Queen Lane Raw Water Pump Station Electrical Improvements  
4530-40 Ridge Avenue  
File #:291-93

Submission to City of Philadelphia Art Commission  
Cover Letter  
January 30, 2024

# **Queen Lane Raw Water Pump Station Generator Project**

**Final Approval**

# Generator Use – Noise Impact

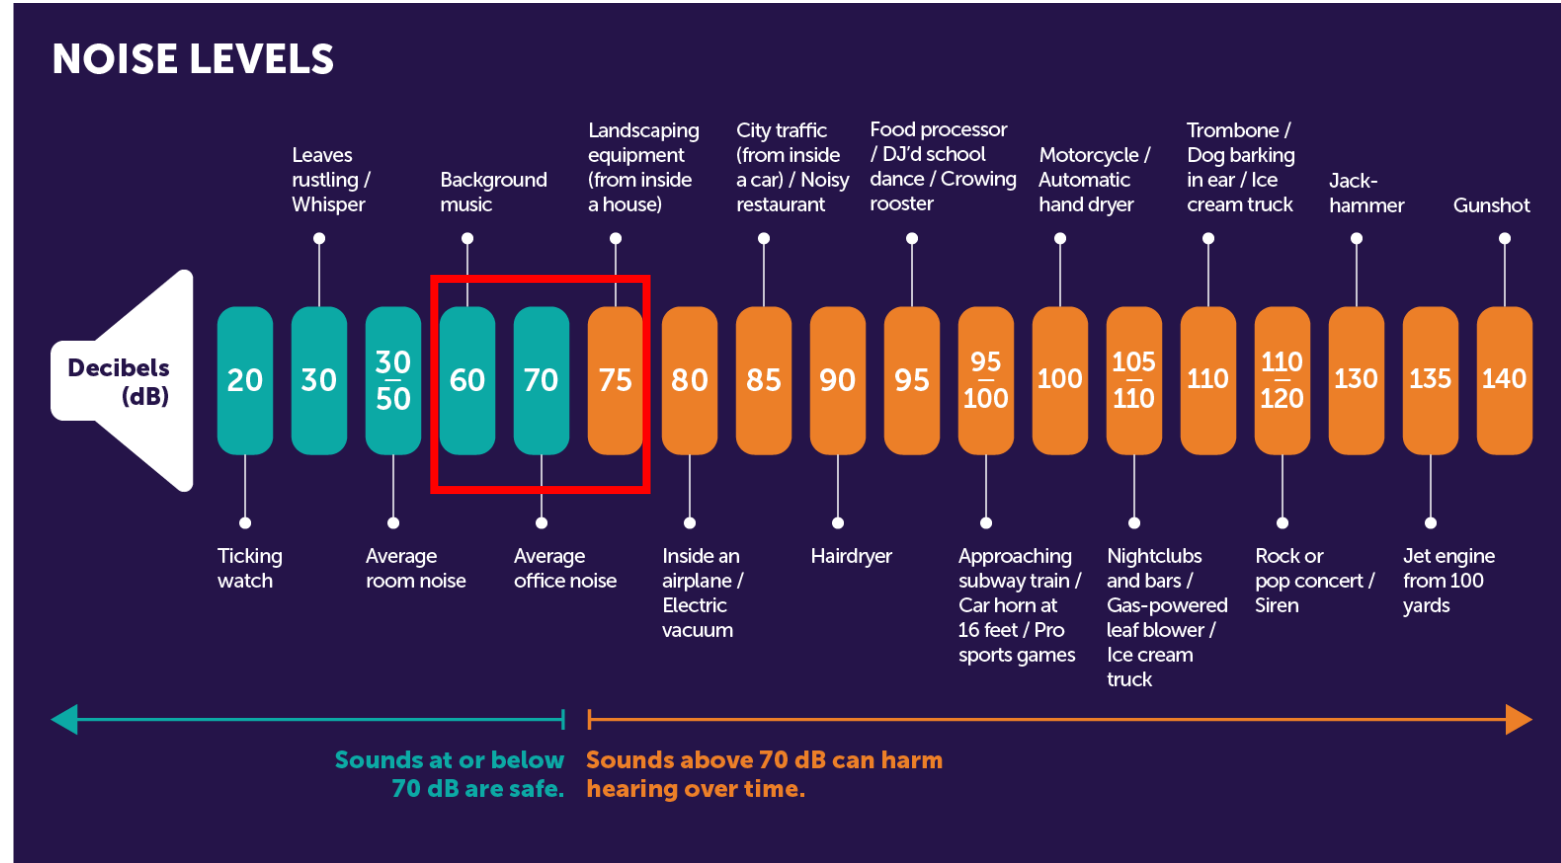
1. Sound Impacts
2. Construction Access
3. Landscaping Design and Maintenance
4. Visibility of Electrical Yard from the Sidewalk
5. Lighting impact

- Emergency standby generators operated in routine O&M and power outages only.
- Generator O&M includes:
  - Minimum O&M run time: 12 hours in a year.
    - (monthly maintenance)
  - Maximum O&M run time: 52 hours in a year
    - (weekly maintenance)

- Contract requires Level II – Sound Attenuation
  - 72-75 dB range at a 25 foot range
    - Noise level equivalent to landscaping equipment (from inside a house)
  - 65-70 dB range at a 50 foot range
    - Noise level equivalent to an occupied open office space
- Generators are ~70 feet away from adjacent sidewalk
